CITY OF NOVI CITY COUNCIL
FEBRUARY 23, 2026

SUBJECT: Consideration for tentative approval of the request of Avalon Investment Group, LLC, JSP25-02 Camelot Parc Townhomes, for a Planned Suburban Low-Rise (PSLR) Overlay Development Agreement Application and Concept Plan.

Re: Camelot Parc – PSLR Overlay Plan Revisions

AVALON PARK DEVELOPMENT, LLC
 CAMELOT PARK TOWNHOMES
 PSR OVERLAY CONCEPT PLAN
 LAYOUT PLAN

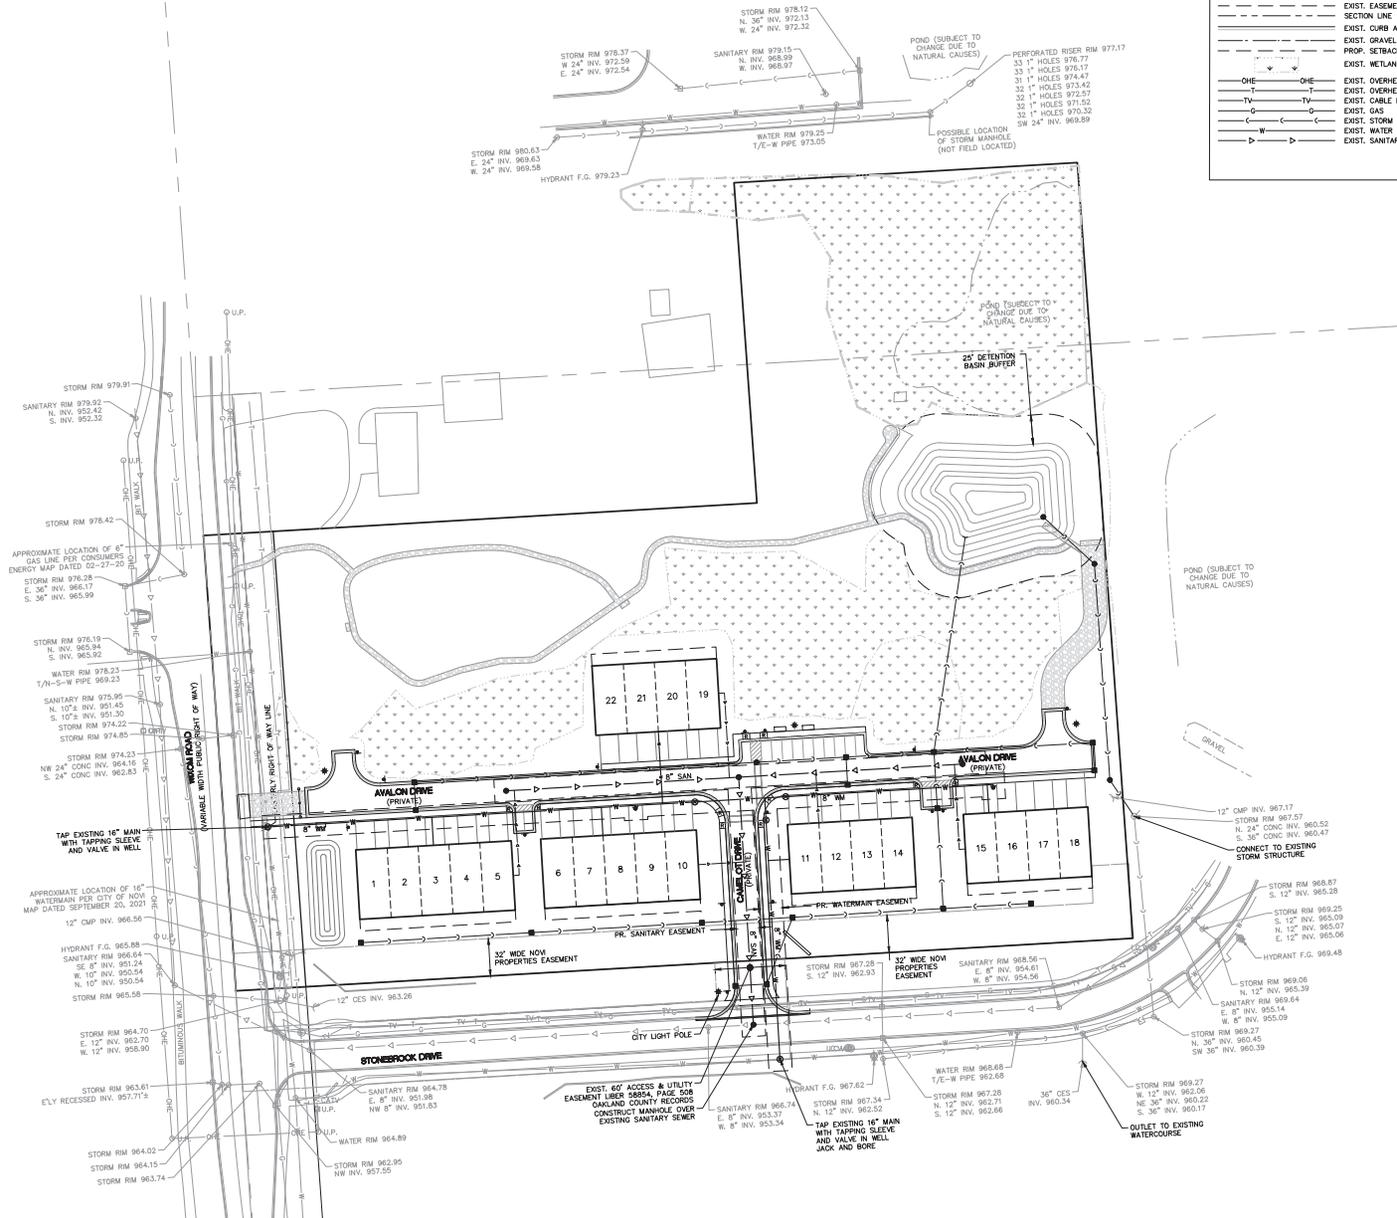
8. Note 9 on sheet 4 has been modified to reflect that the emergency gate must be closed prior to the issuance of the first certificate of occupancy rather than the first building permit in order to allow construction traffic to utilize the emergency access drive as long as possible.

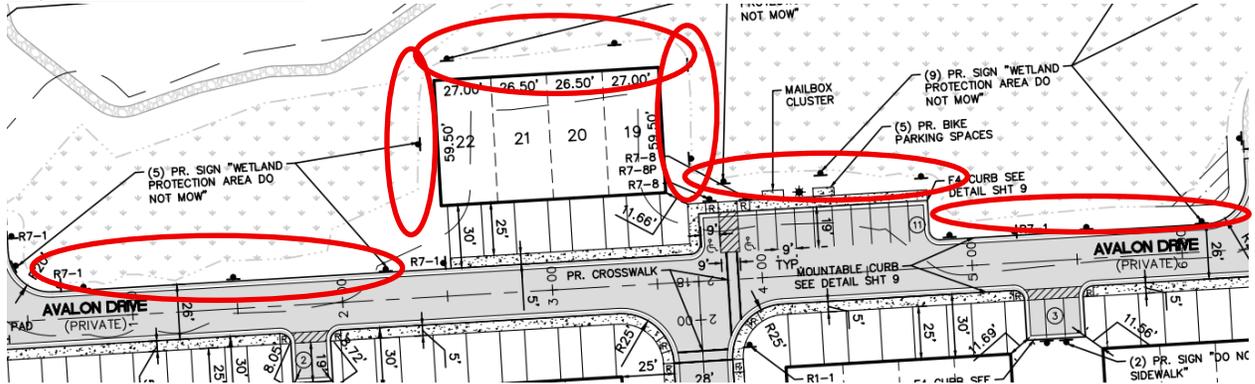
Requested edit: In future submittals, buffer impacts should be differentiated by permanent and temporary impacts (if applicable). If impacts are temporary, descriptions or sequencing should be provided showing how the temporary impacts will be restored. The temporary wetland restoration sequencing provided on Sheet 7 can be applied to any temporary buffer impacts – the header will need to be updated. Identify any temporary buffer impacts using a different symbology in the site plan.

Requested Placement locations

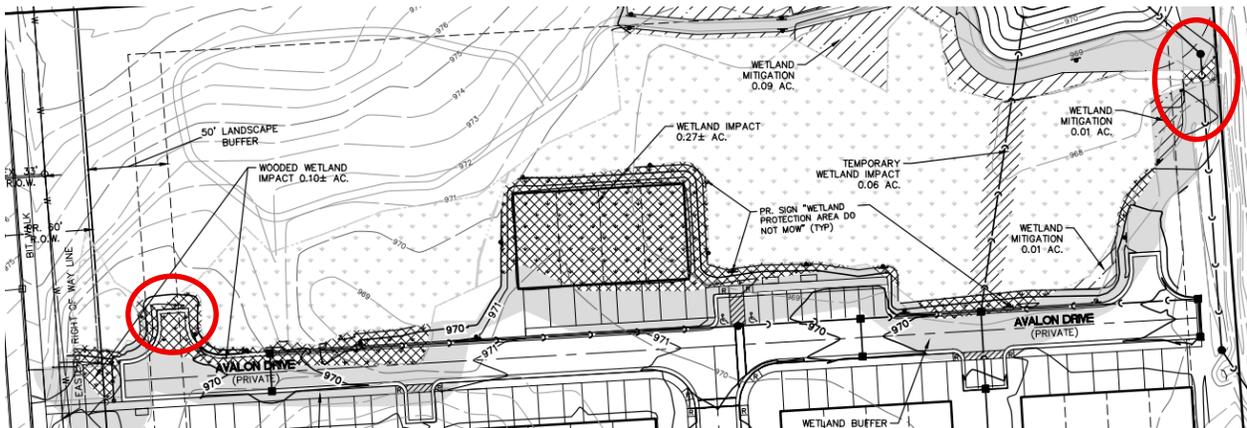
Due to the extensive proposed loss of wetland buffer along the southern remaining wetland area, it is requested that the applicant perform environmental enhancement along the southern portion of the remaining wetland (see screenshot below). The applicant should plant at least three different species of wetland rated shrubs throughout the southern boundary of the wetland. This will allow a small separation from the wetland and the proposed development. Additionally, it will deter any accidental mowing of the wetlands and remaining buffer areas. Shrubs could include three of the following species:
